**From:** [Jonathon Clarke](#)  
**To:** [REDACTED]  
**Subject:** RE: Premium: Kings Quarry Fast Track (Stages 2 & 3) - Substantive Application complete  
**Date:** Monday, 16 June 2025 3:57:41 pm  
**Attachments:** [REDACTED]

I have reviewed the AEE dated 24 April 2025 by B&A and specifically the Assessment of Noise Effects dated February 2025 by Hegley Acoustic Consultants.

This is a Fast Track application to carry out Stage 2 quarrying comprising extraction of approximately 500,000 tonnes of aggregate per year for 45 years.

**Figure 3 reproduced**

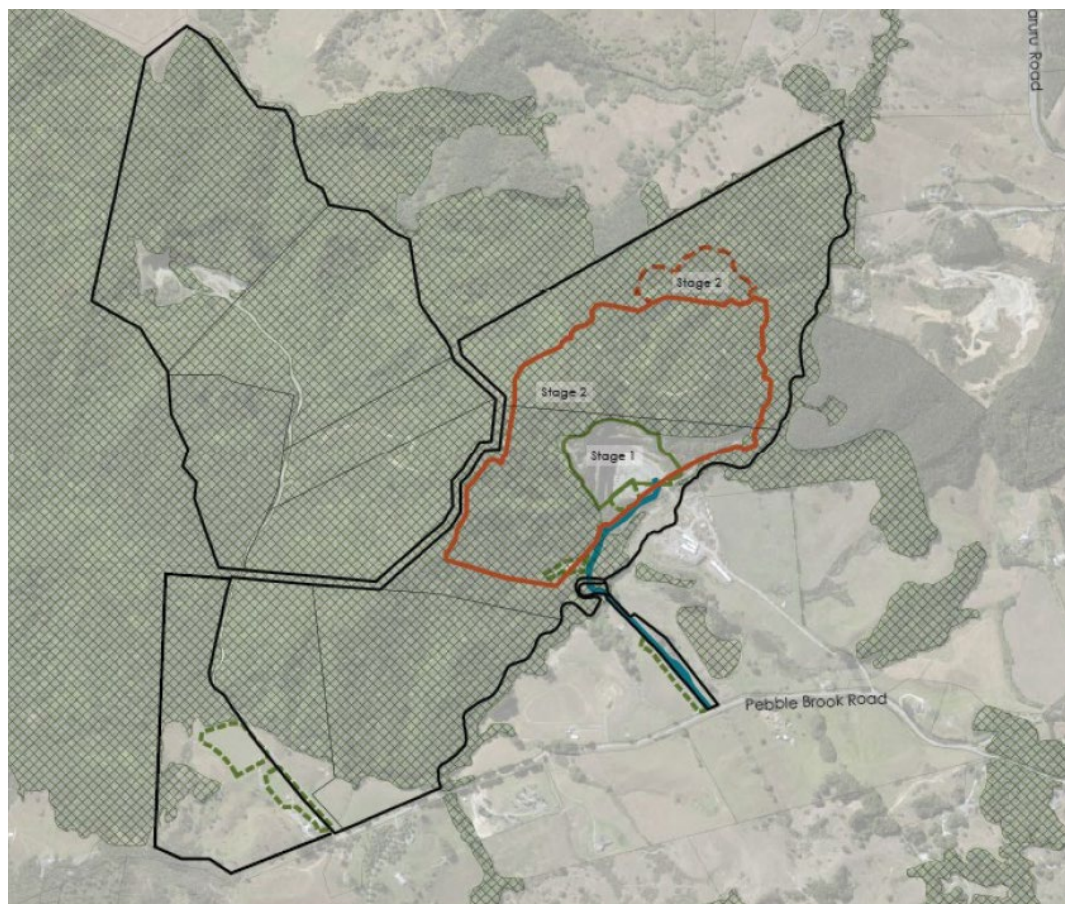
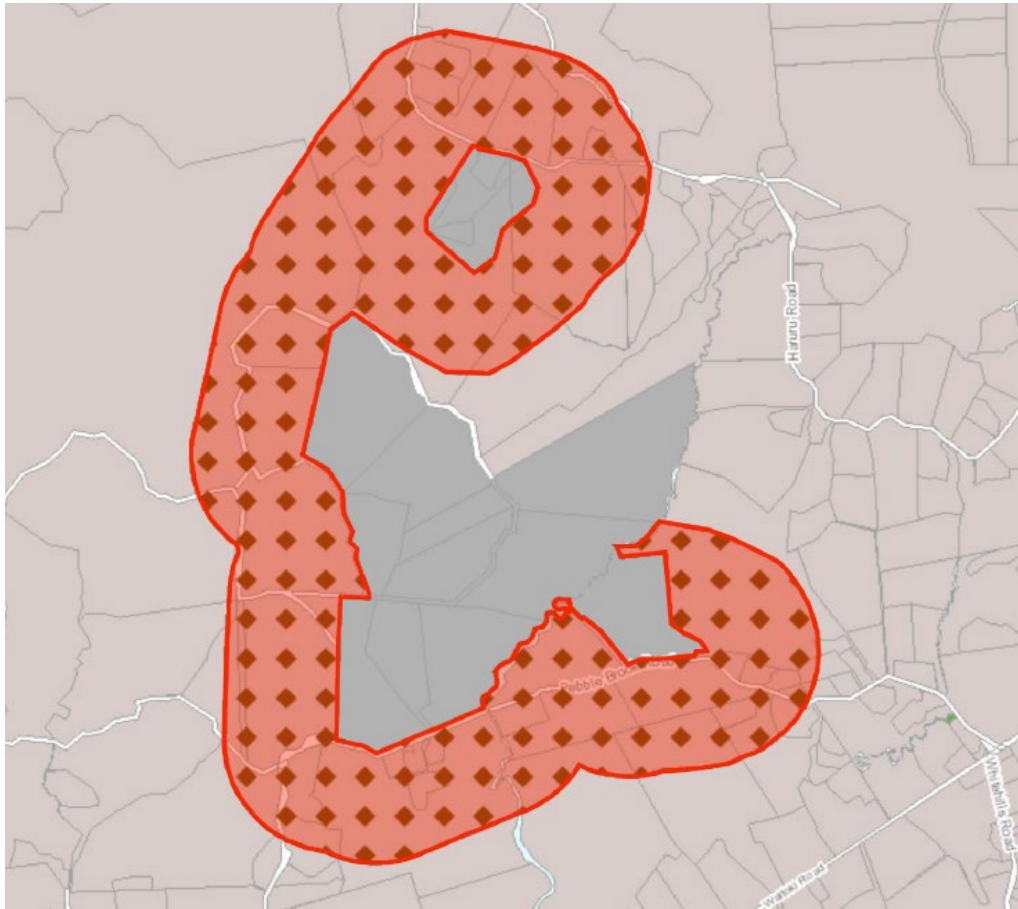
As shown above, a quarry buffer overlay is located around the majority of surrounding land to avoid reverse sensitivity effects on quarry operations that can result from subdivision and new development occurring in close proximity.

As shown above (grey area), all Stage 2 quarrying (over 54.5ha) will occur within the Special Purpose – Quarry Zone. Surrounding land is zoned Rural – Rural Production.

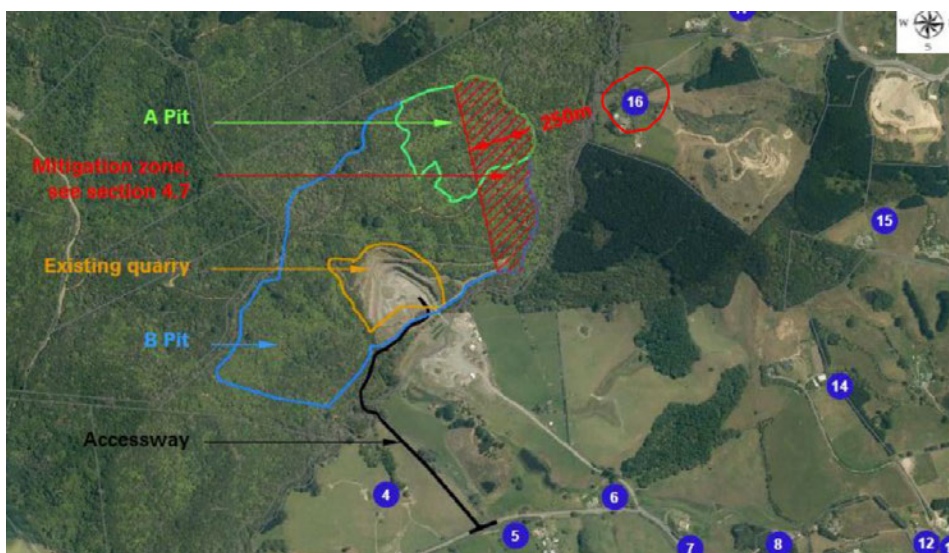
It is reported '*Stage 2 will be a continuation of the Stage 1 quarry activities. No new plant or activities are proposed.*' Therefore, I agree any change in noise effects will be due to the specific locations of the plant relative to the closest or most exposed notional boundaries

and, the number of truck trips.

A brief description of Stage 2 quarry activities is provided – this looks representative and is adequate to predict noise (and vibration) levels. This includes an increase in truck trips (in and out) from the consented 50 truck trips (i.e. 100 movements) to 94 truck trips (i.e. 188 movements). It is important to note the consented two truck trips between 6.30am and 7am does not change (i.e. when the permitted night time noise level applies).

It is also worth emphasising that proposed quarry activities will not change from Stage 1 consented operating hours and that no quarry activities (except for the two truck trips) or overburden removal will occur before 7am, Monday to Saturday.
